FLEET PRODUCTS

Quality Products • Trusted Service • Competitive Prices

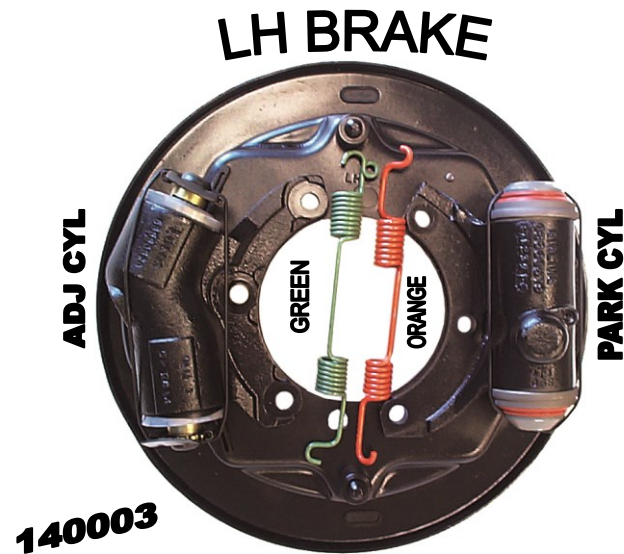
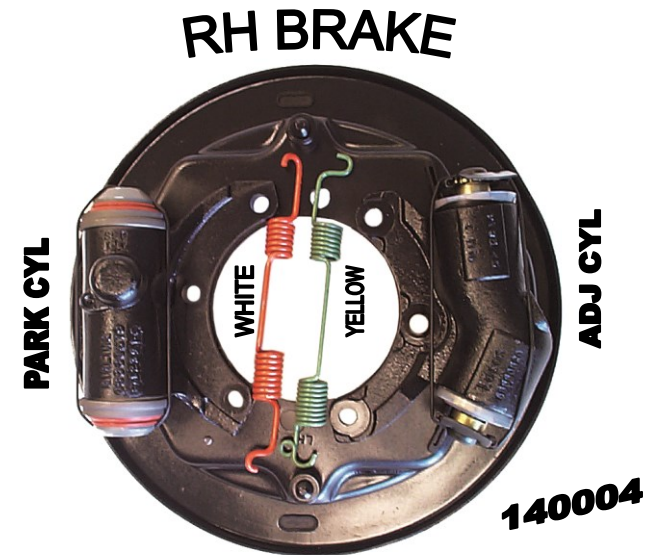
IMPORTANT: Our kit now contains a white and an orange return spring. These 2 springs now replace a red return spring that was common to both **RH** and **LH** brakes prior to Jan, 1992. These return springs are color coded and **must** be assembled as shown in diagram.
